Subject: SQUEAK NOISE FROM RIGHT FRONT DRIVESHAFT	Bulletin No.: 03-002/18
	Last Issued: 08/17/2018

1	Inner joint boot set
2	Dust cover
3	Oil Seal

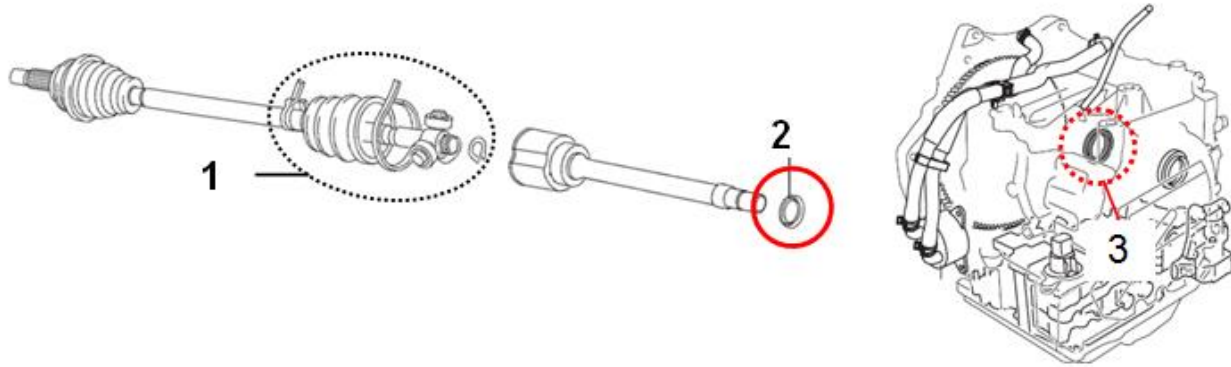
Some vehicles may exhibit a squeak noise from the right front driveshaft at the transaxle when driving. This concern is likely to occur when driving at speeds between 37-50 mph (60-80 km/h) with the ATF at normal operating temperature. The noise is caused by stick/slip between the oil seal at the transaxle and the dust cover of the driveshaft. To correct this issue, the thickness of the dust cover has been increased.

1. Verify concern
2. Replace the dust cover and the transfer oil seal with modified ones according to the instructions on MGSS (FRONT DRIVE SHAFT REMOVAL/INSTALLATION).
